**ITEM B.19**

November 20, 2014 HPO File No. 141119

#### CERTIFICATE OF APPROPRIATENESS

Proposal: Alteration - Construct a two story 1,711 square foot addition to the rear of a contributing one story 1,222

### **SOUTH ELEVATION - FRONT FACING EUCLID STREET**

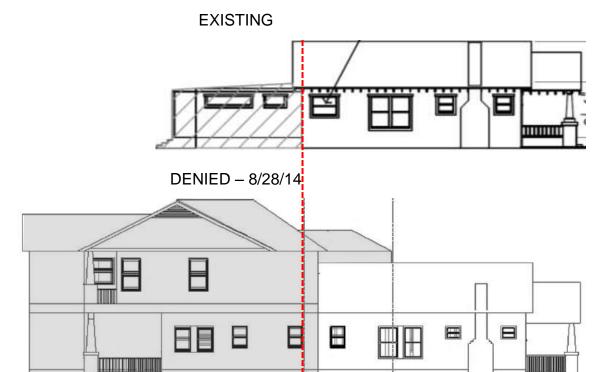
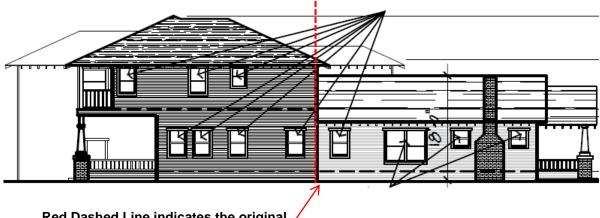
S	D	NA		S - satisfies D - does not satisfy NA - not applicable
			(1)	The proposed activity must retain and preserve the historical character of the property; The mass of the addition visually overwhelms the existing structure. This alters the character of the house from a simple one-story residence to one that is much larger and more complex.
$\boxtimes$			(2)	The proposed activity must contribute to the continued availability of the property for a contemporary use;

(9)	The proposed design for any exterior alterations or addition must not destroy significant historical, architectural or cultural material and must be compatible with the size, scale, material and character of the property and the area in which it is located; The addition's large size and complicated massing are not of compatible scale with the

existing house and the Woodland Heights Historic District and is visually prominent as seen from the street. Also, the encroachment of the addition on the existing house will cause removal of historic material.
□ □ (1)	The setback of any proposed construction or alteration must be compatible with existing setbacks along the blockface and facing blockface(s);
□ □ ⊠ (1	The proposed activity will comply with any applicable deed restrictions.

Staff finds that the proposed addition would likely conform to all 11 criteria if the east side portion of the addition (the attached porte-cochere with upstairs living space and balcony) were moved back approximately 7' away from the front property line so that it is situated 55' from the front property line instead of 47'. This would reduce the visibility of the addition and help visually separate the garage and porte-cochere section from the residence, giving it the appearance of a rear detached two story garage apartment when viewed from the street.

### FIRST FLOOR PLAN

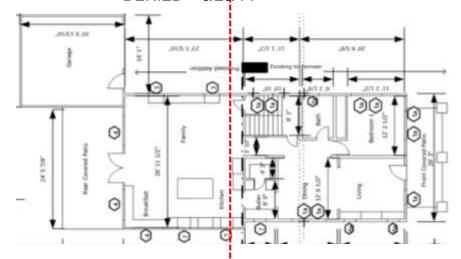
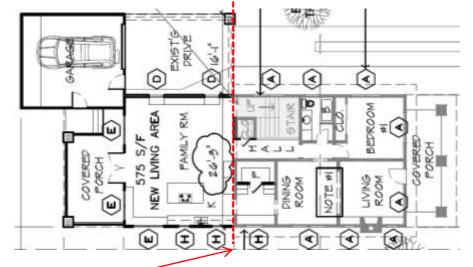
(8)	Proposed additions or alterations must be done in a manner that, if removed in the future, would leave unimpaired the essential form and integrity of the building, structure, object or site;  The second floor of the proposed addition will encroach on the rear 13' of the original home. This jeopardizes the essential form and integrity of the historic structure because the existing building fabric underneath this encroachment must be removed or irreparably altered in order to support the added weight of the new second floor.
